SERVICE BULLETIN

EC15-017

December 1, 2015

2014 – 2015 TAXI; MIL ON WITH DTC P0101

Figure A

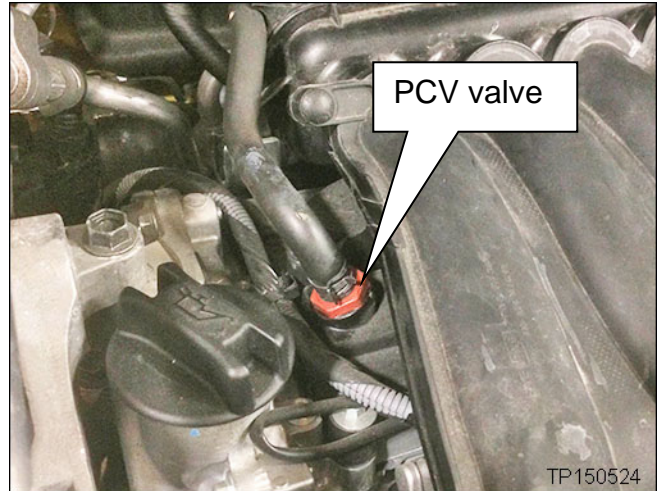
1. Open the engine hood and locate the PCV valve.
2. Replace the PCV valve:
 - If needed, refer to the Electronic Service Manual ESM, section EM-Engine Mechanical, for replacement information.
 - Use the new PCV valve listed in the Parts Information.
 - The new PCV valve is “black” color.
 - The old PCV valve (the one you are replacing) will likely be “orange” color.

DESCRIPTION	PART NUMBER	QUANTITY
PCV Valve (Black Color)	11810-6N202	1
